Plan Commission

Special Meeting

Agenda

SUBJECT: Consideration and possible action on major design exceptions from Zoning Ordinance Sections 14-92(4)(d), 114-33(3)(b) [Table 3-3], and 14-33(4)(c), related to balconies and upper-level step-backs at 550 William ST (Parcel ED-875-1).

TADYCH - PHASE 1 DEPERE MIXED USE

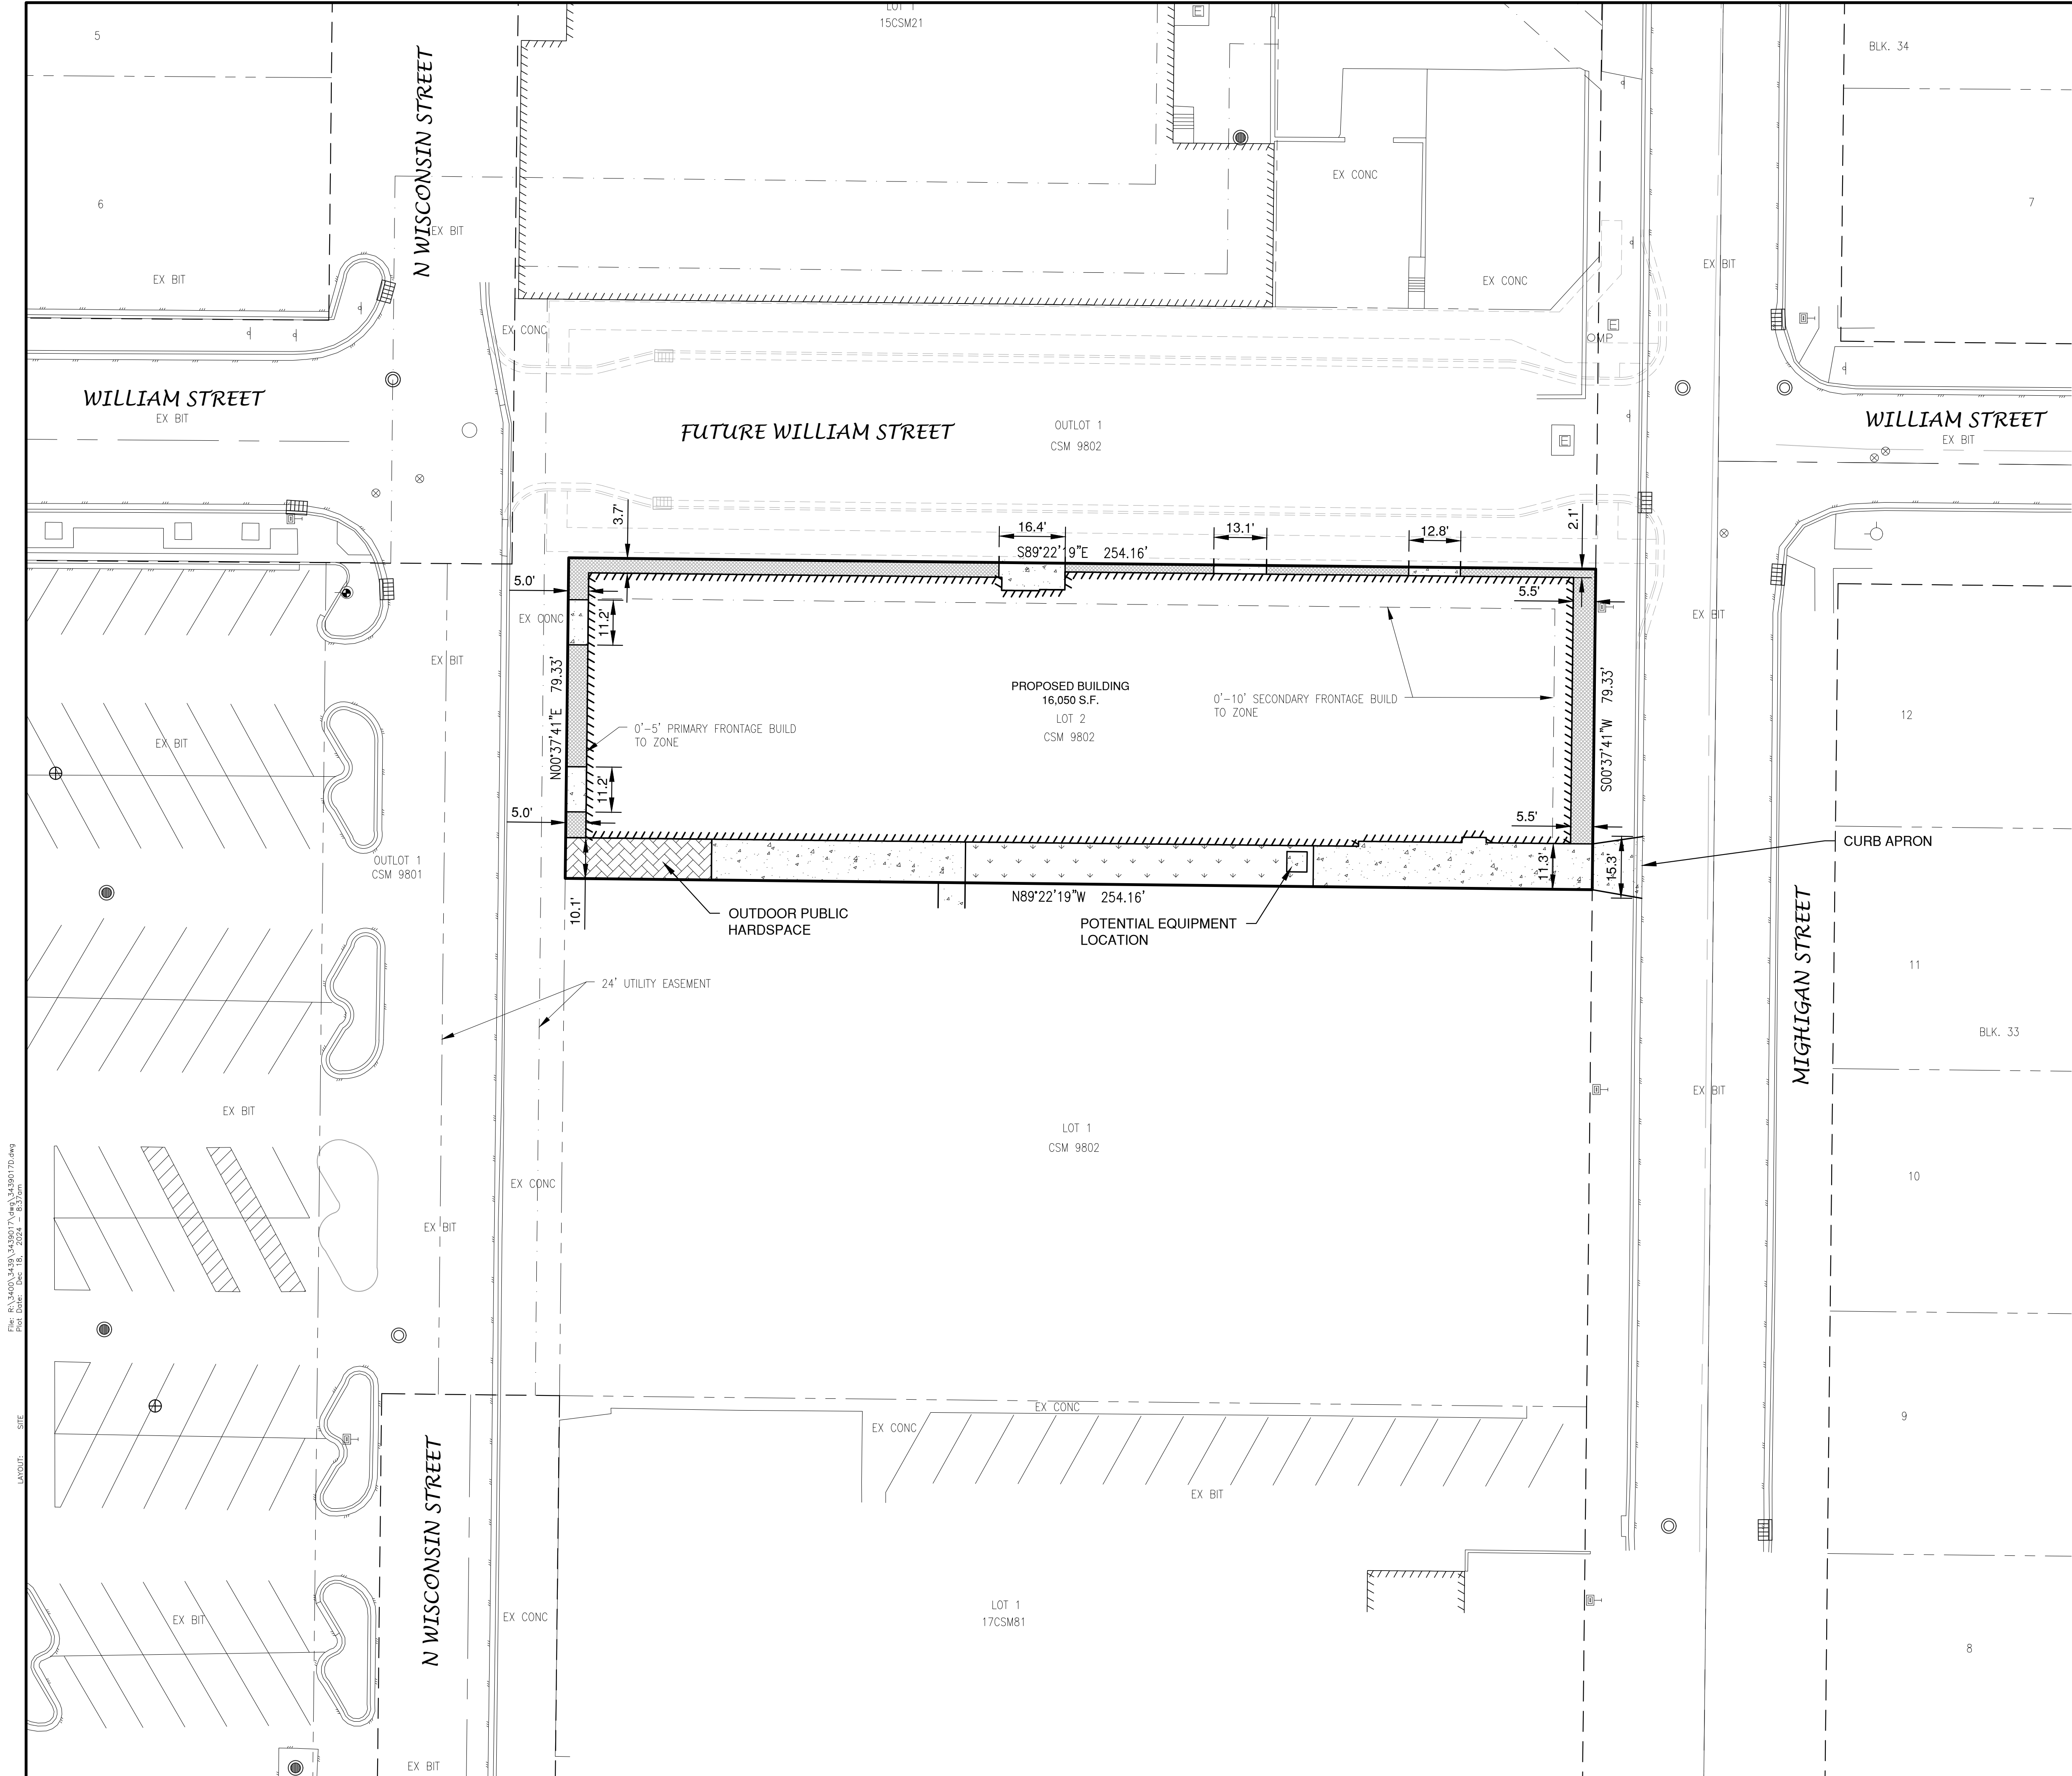
STEP BACK SETBACK
10' ZONING STEP BACK ABOVE THIRD STORY REQUIRED PER 14-33(4)(C)

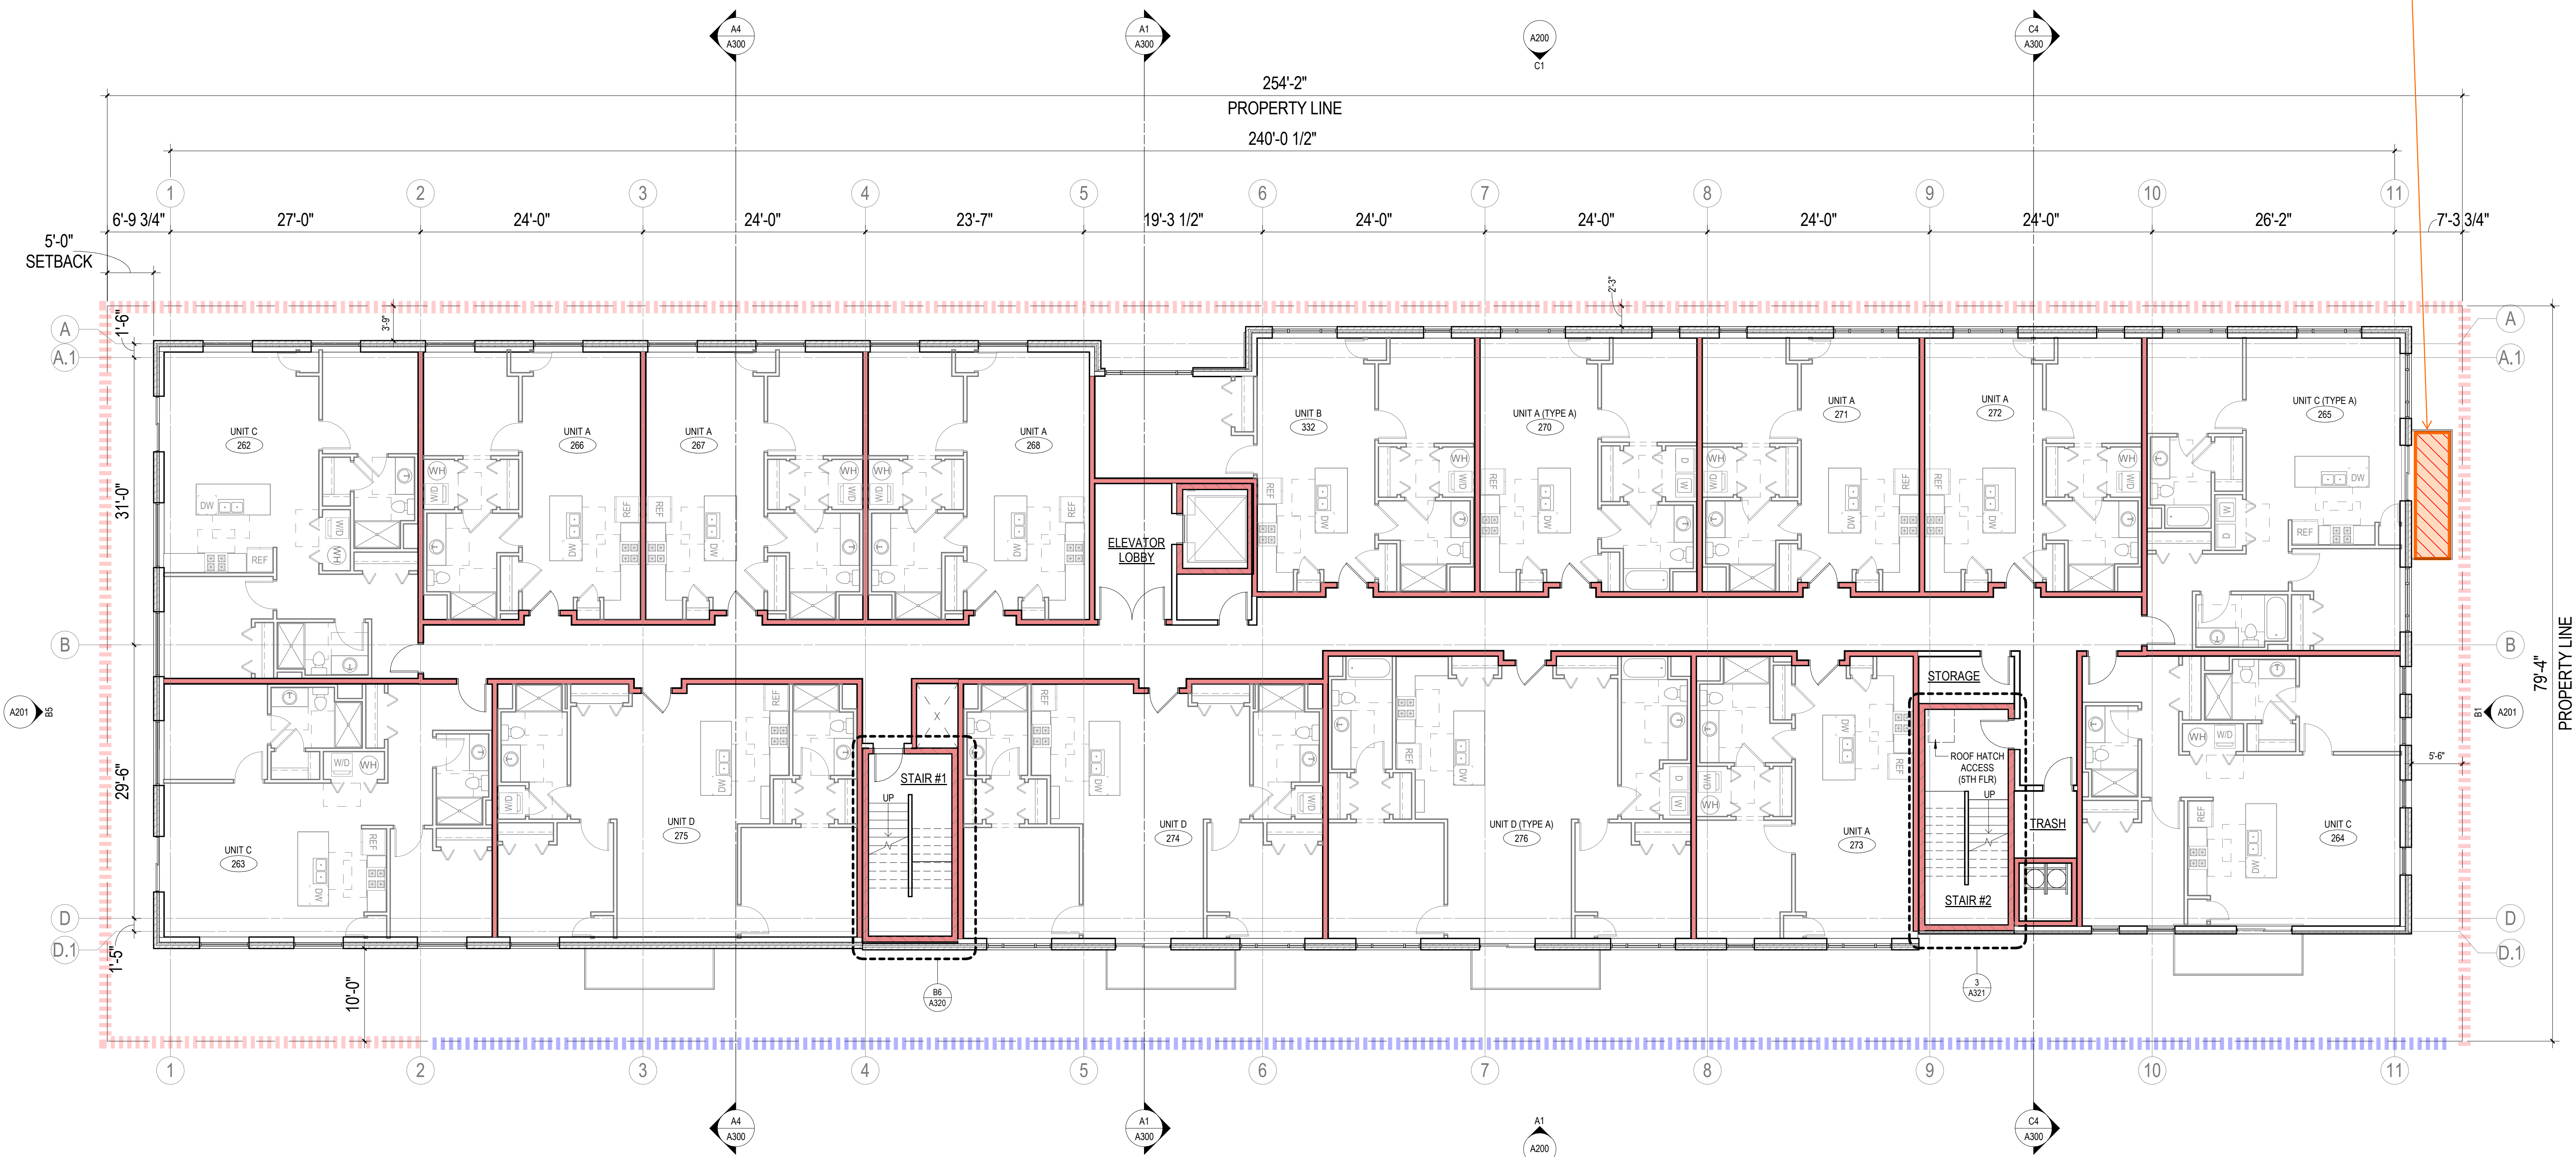
DESIGN EXCEPTION REQUEST 1:
ALLOWANCE REQUESTED FOR
PROTRUDING BALCONIES TOWARD
MICHIGAN ST. TO MATCH BUILDING
AESTHETIC OF CANTILEVERED/ CABLE
TIED AWNINGS

DESIGN EXCEPTION 2

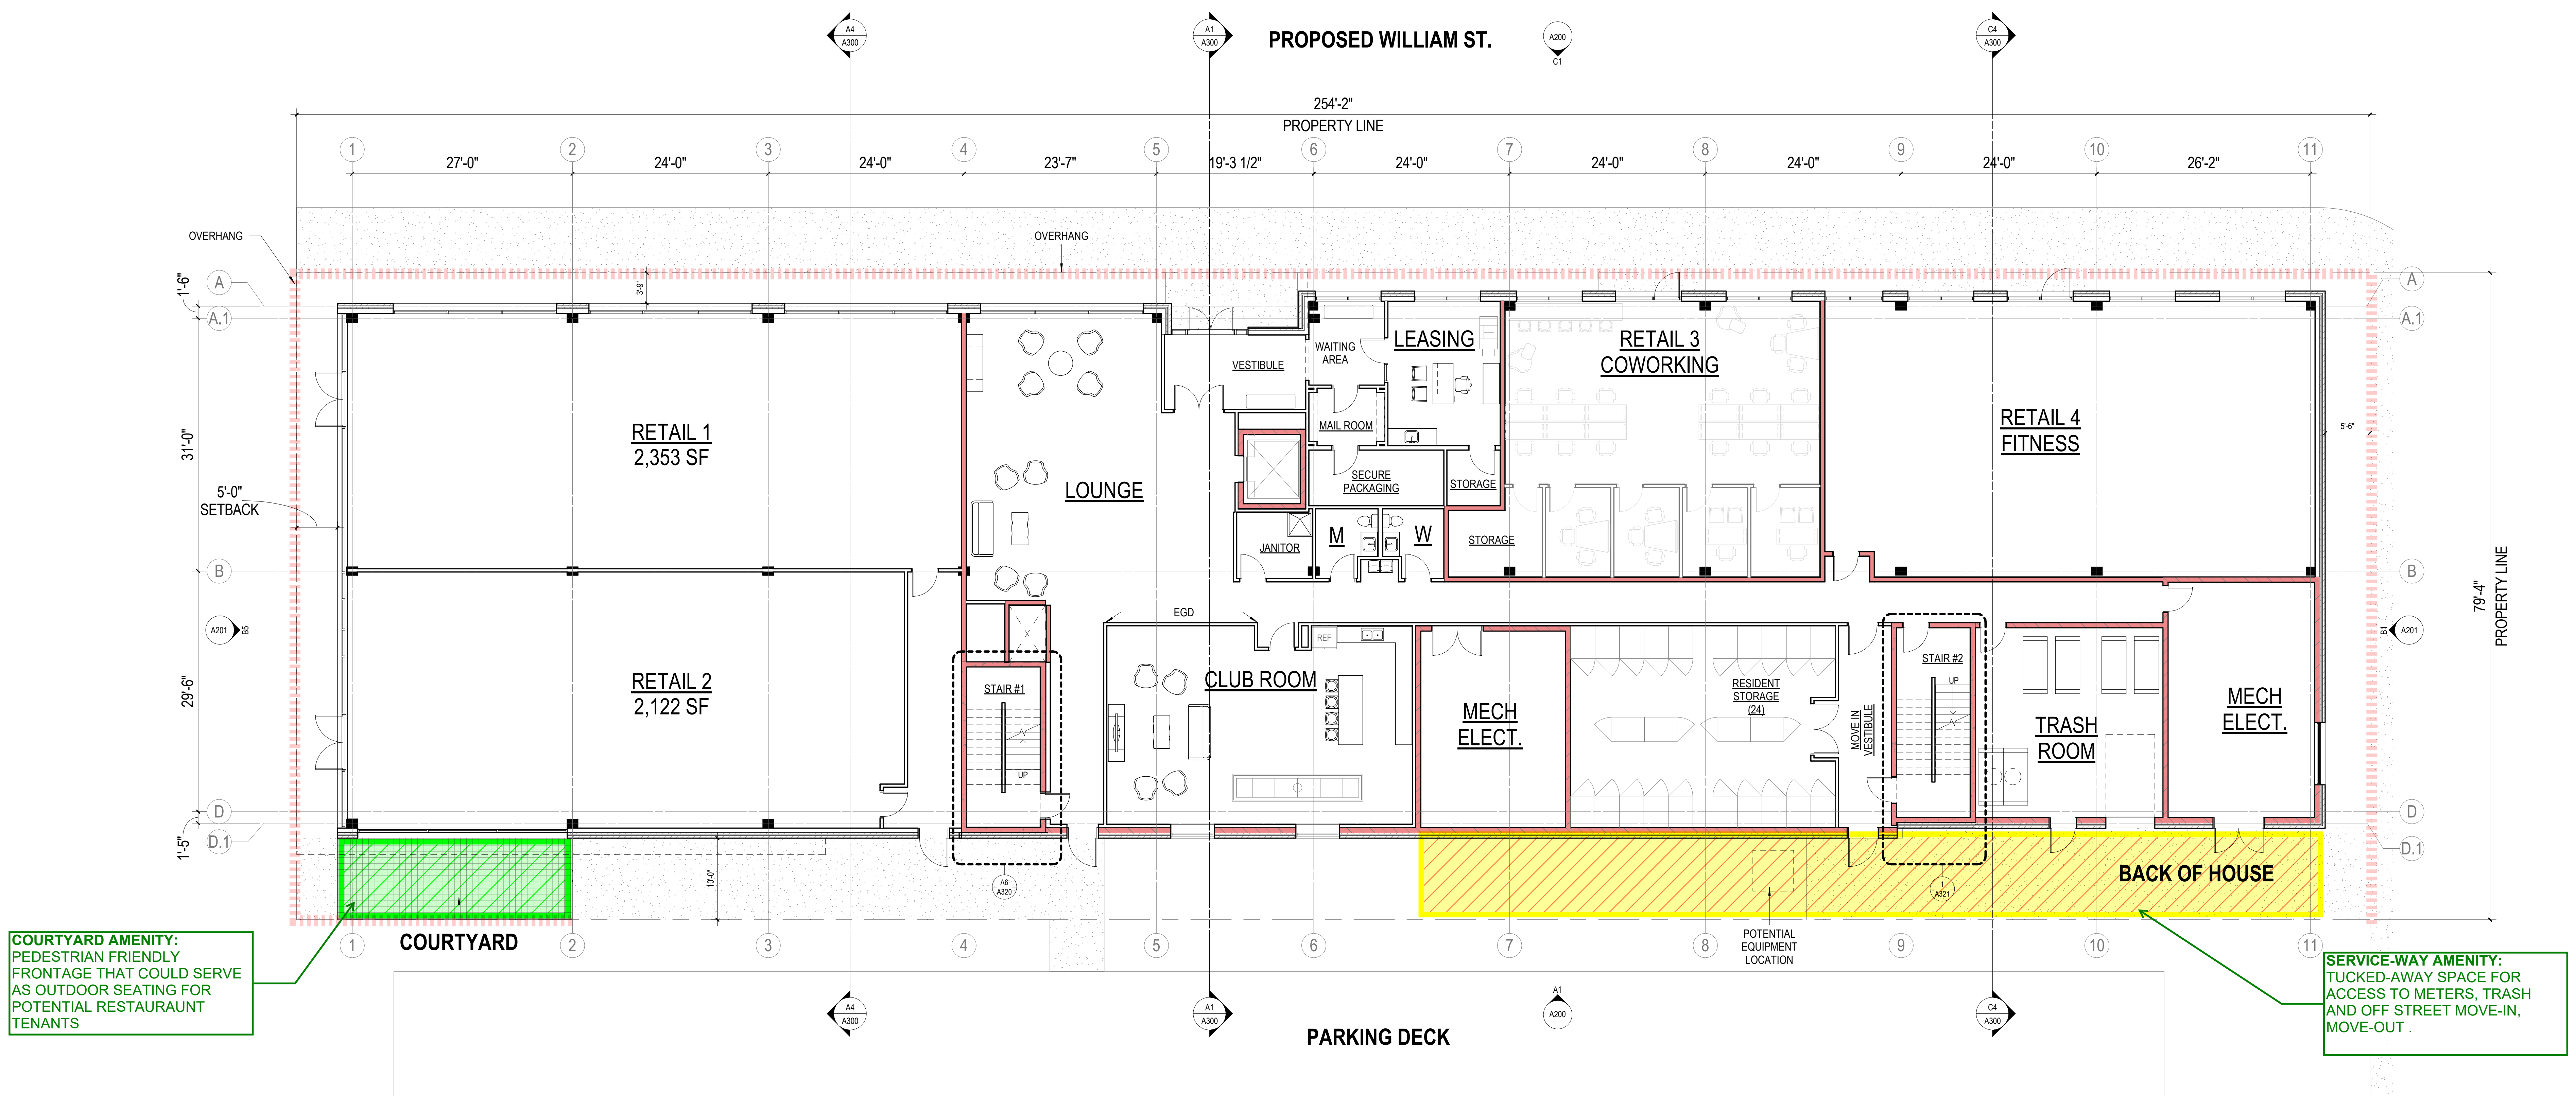
PUBLIC WAY FRONTAGE
